Date: November 9, 2017 File: 20142670.020.C.01.00

Project: Water Main River Crossings

Subject: Addendum #1

## ADDENDUM

OHTAKI BRIDGE AIR-VALVE SERVICE PLATFORM

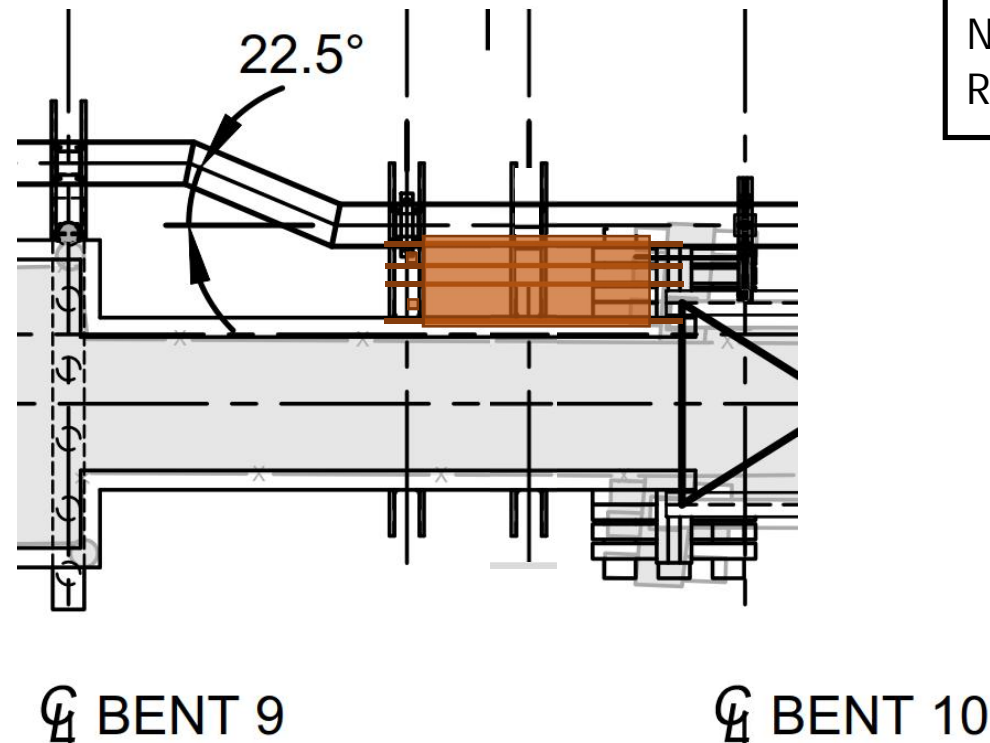
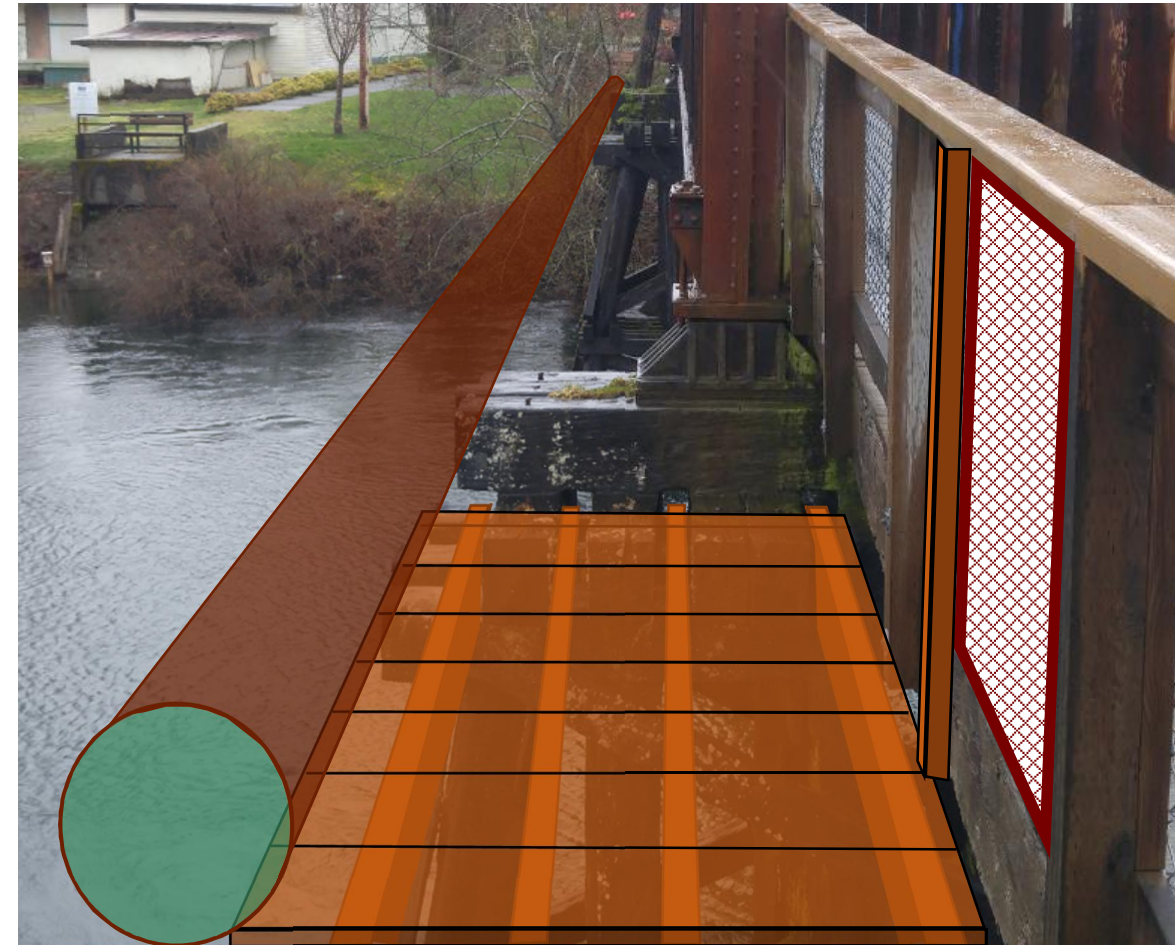
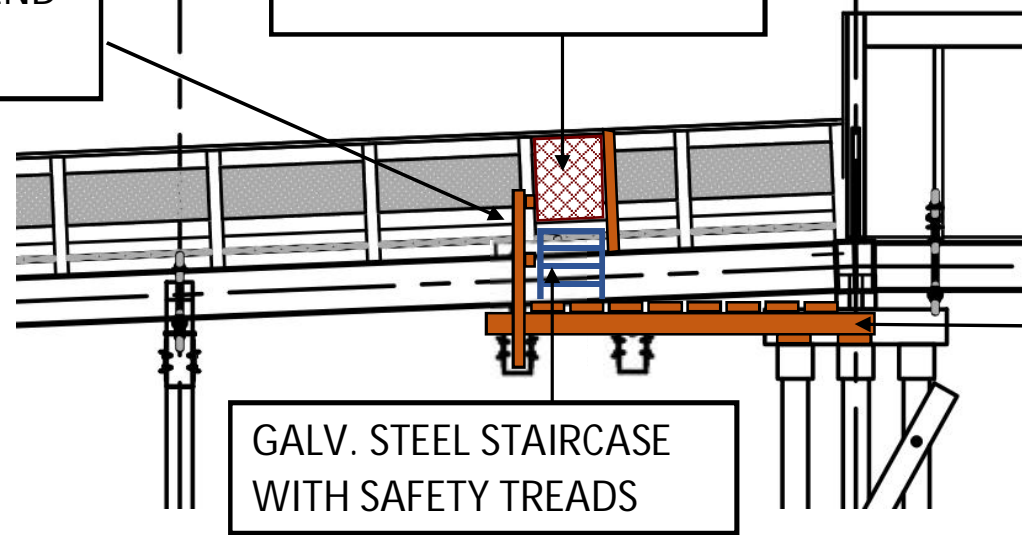
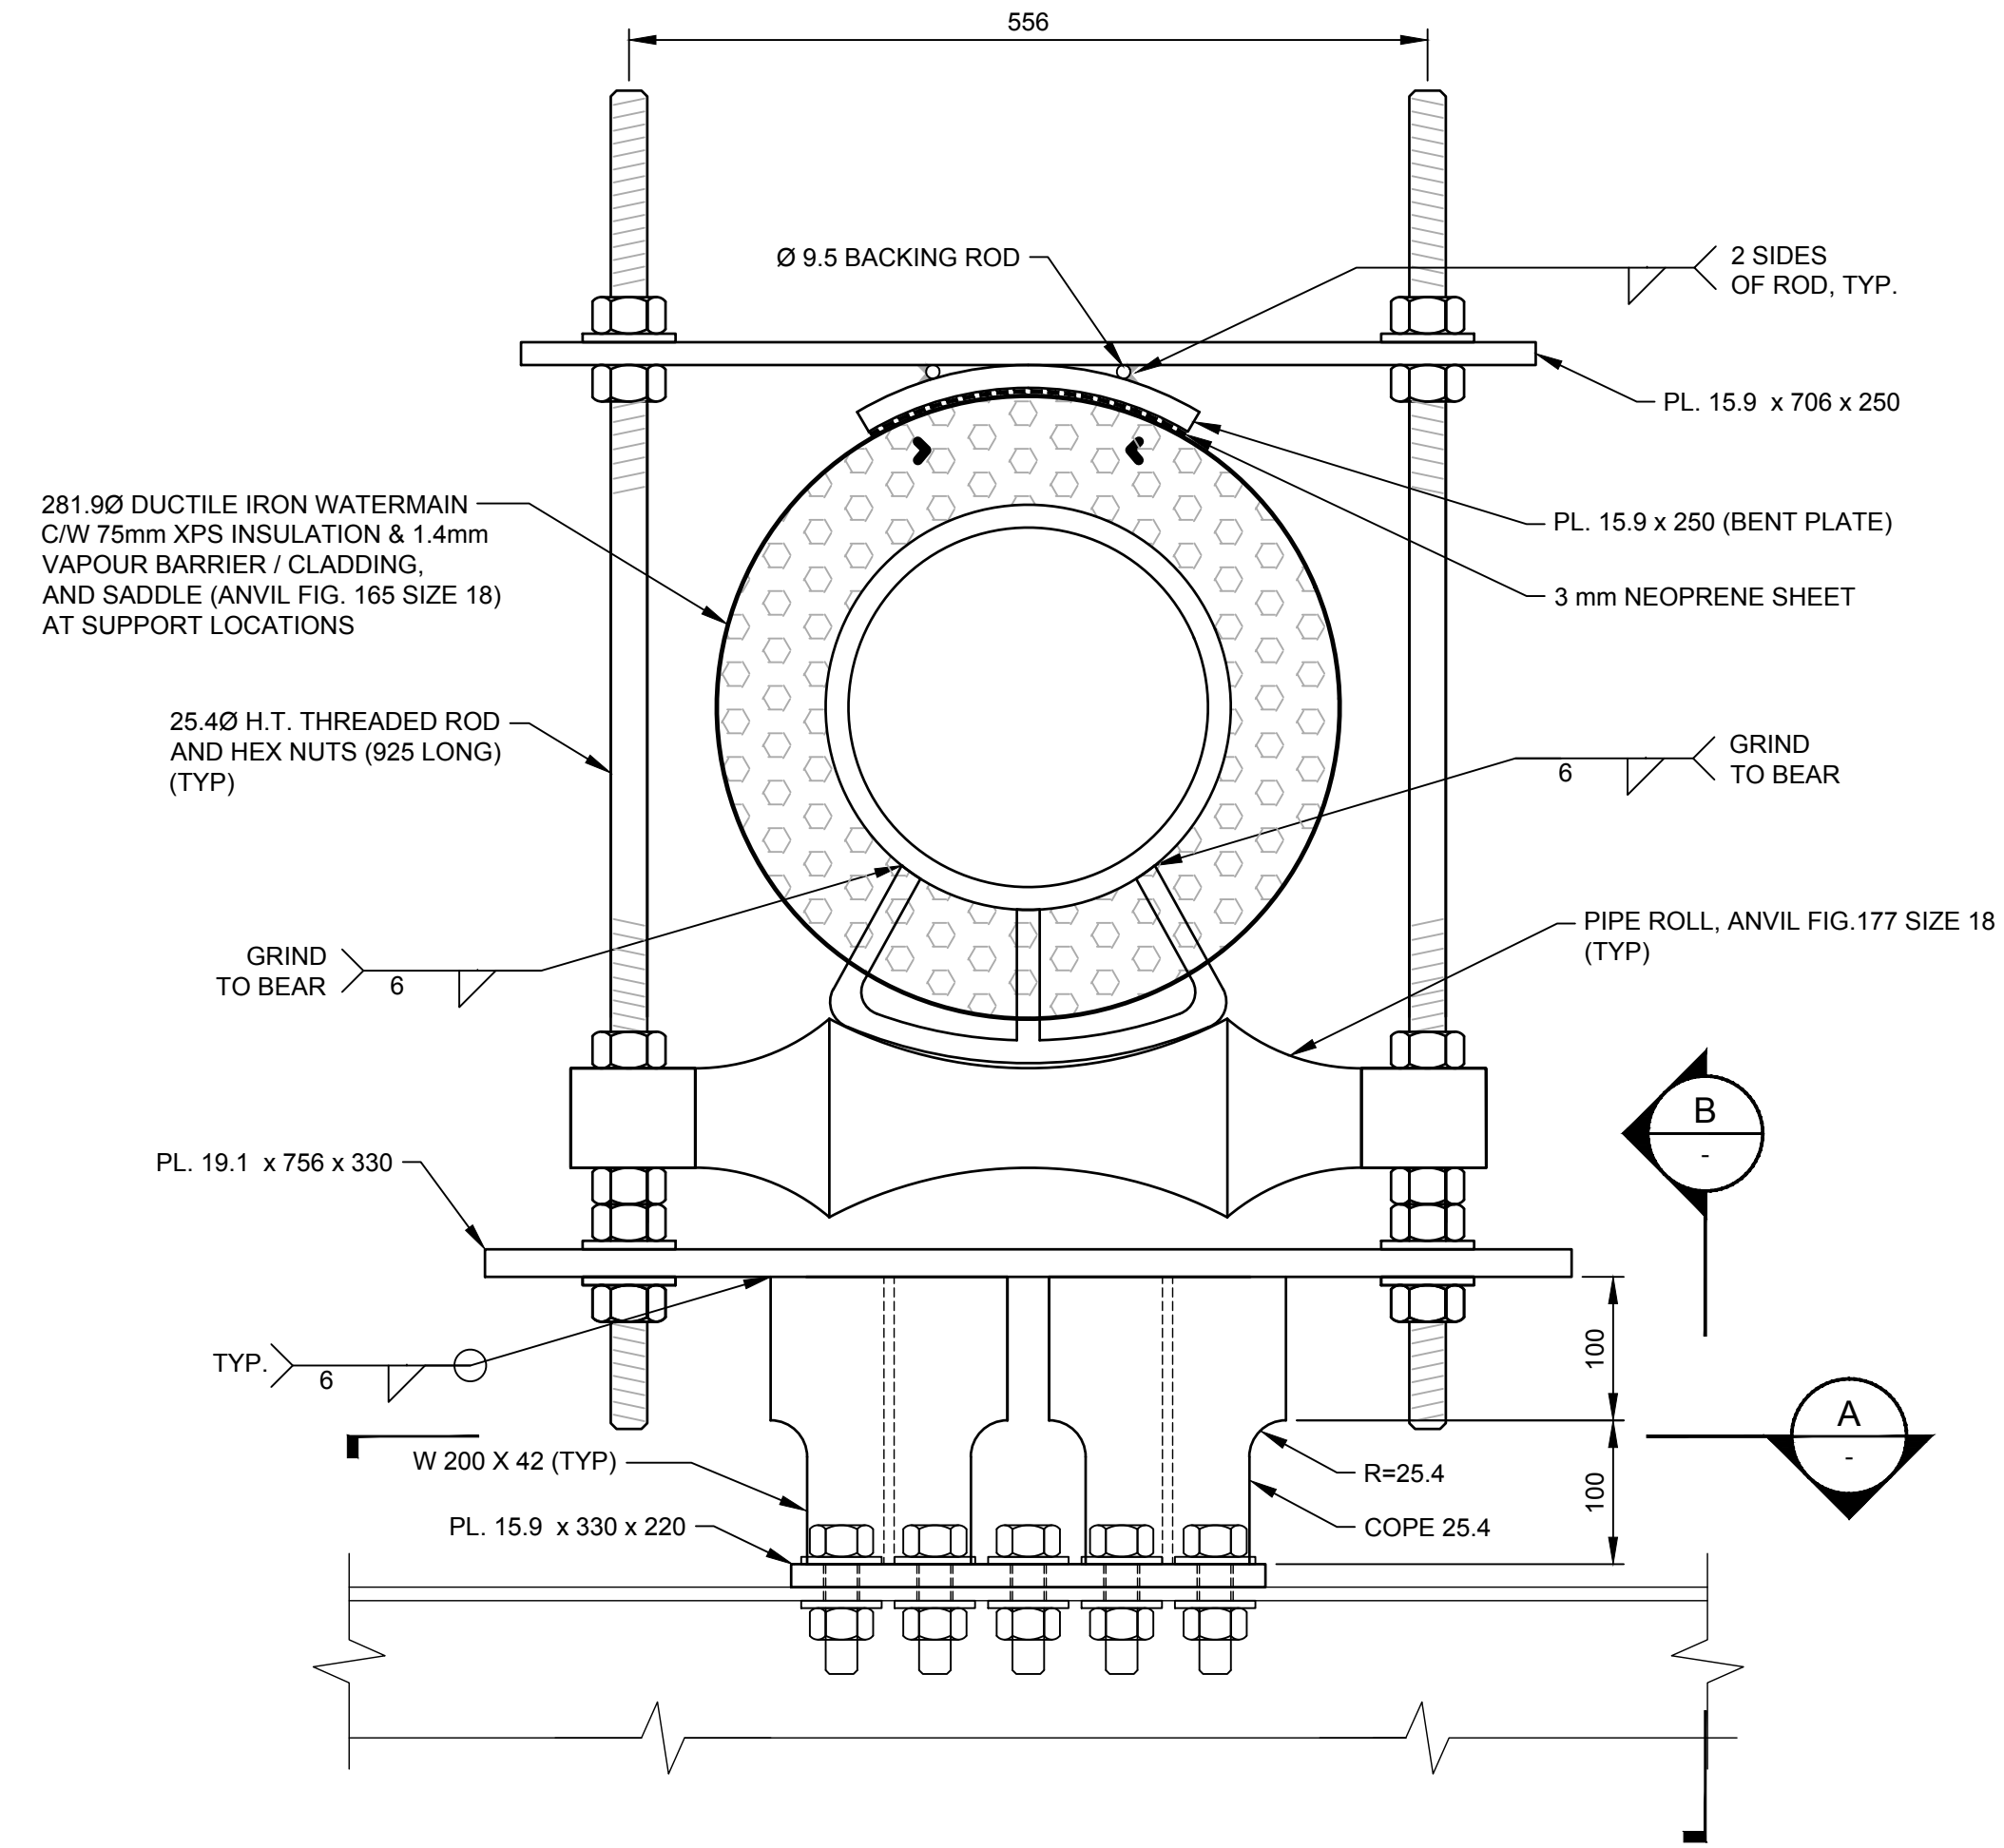
15. **Question:** Can Associated Engineering provide details for the service platform for the air valves?

**Answer:** The service platform for Ohtaki is to be design-build in accordance with sketch S104-SK01 provided with this Addendum. Greendale does not require a service platform, but does require the addition of a lockable access gate to access the air valve, to the specification indicated on the sketch.

ADDITIONAL HANGER  
SUPPORT TYPE SEC C  
ON DWG S-104

GATE WITH NEW POST;  
FIELD ADJUST FENCING

FIELD-FIT 3660 X 1400 SERVICE PLATFORM INCLUDING:

- 4no. 3"x12" TREATED DOUGLAS FIR STRINGERS, WITH 3"x10" OR 3"x8" TREATED DOUGLAS FIR DECKING; FIT TO SUIT IN FIELD BETWEEN PIER BENT AND TWO HANGER SUPPORTS.
- ADDITIONAL HANGER SUPPORT TYPE SEC C ON DWG S-104
- 915 WIDE ACCESS GATE WITH FIELD ADJUSTMENT OF EXISTING FENCING
- END SAFETY FENCING TO SERVICE PLATFORM
- GALV. STEEL STAIRCASE WITH SAFETY TREADS (915mm WIDE NOM.)

STRUCTURAL  
GREENDALE TRESTLE - WATERMAIN SUPPORT SYSTEM  
STRUCTURAL DETAILS - SHEET 2

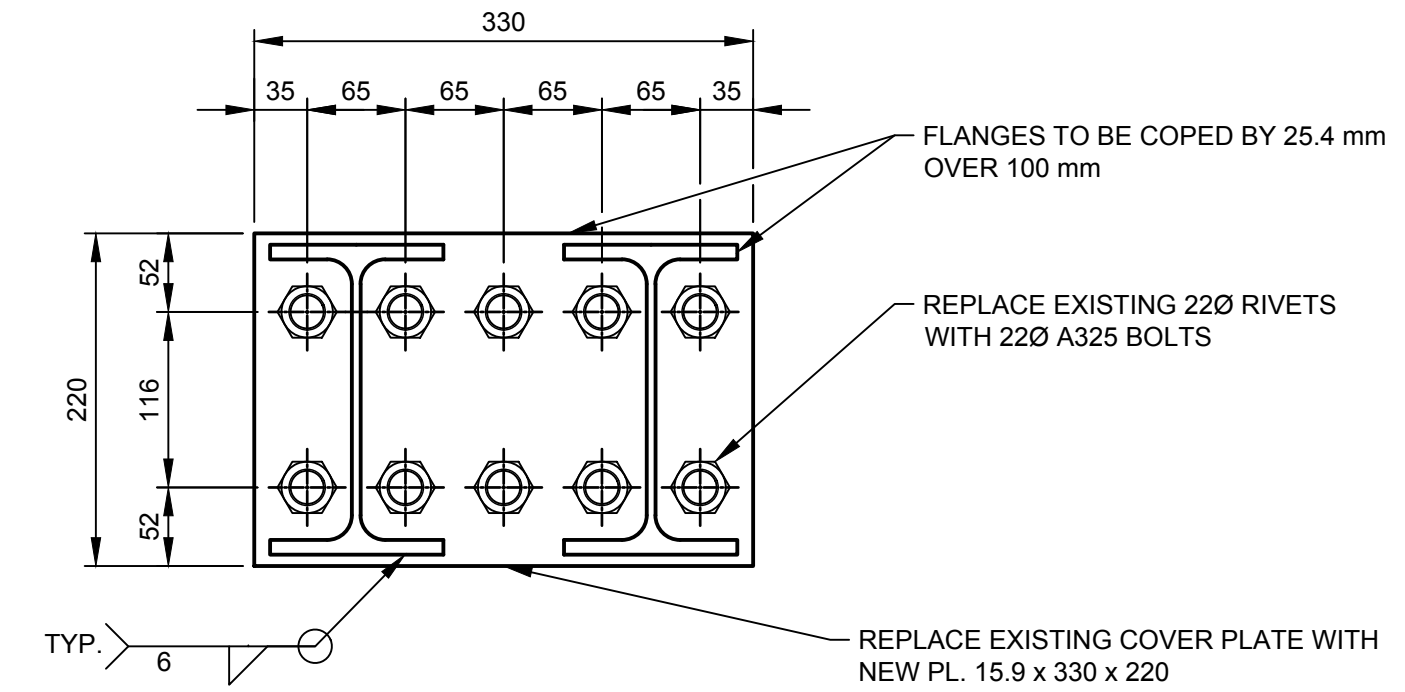
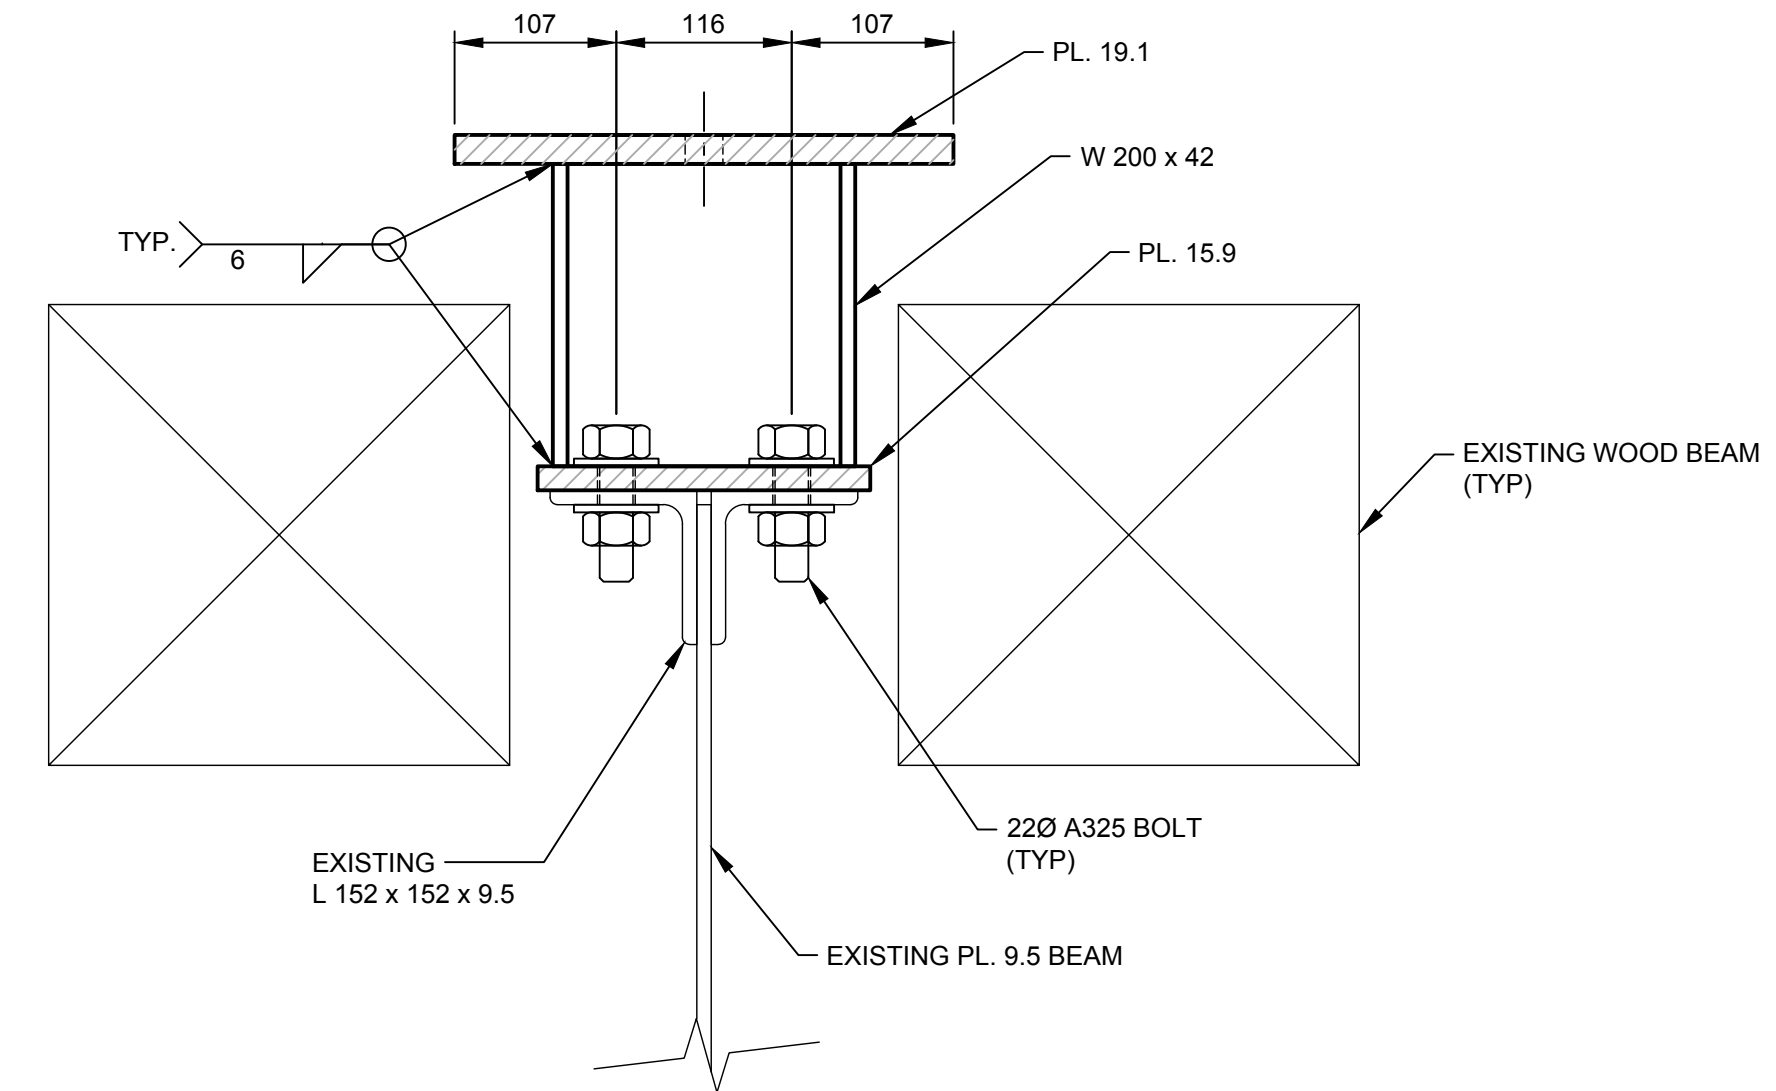
19. **Clarification:** Drawing 2670-02-S-103 has been revised to reflect the dimensions of the existing plate on the Greendale Trestle. See attached.

REV	DATE	DESIGN	DRAWN	DESCRIPTION
1	2017NOV20	C. SCHAPER / J. JIAO / J. MORD / J. DU		REVISED SUPPORT
0	2017OCT20	C. SCHAPER / J. JIAO / J. MORD / J. DU		ISSUED FOR TENDER
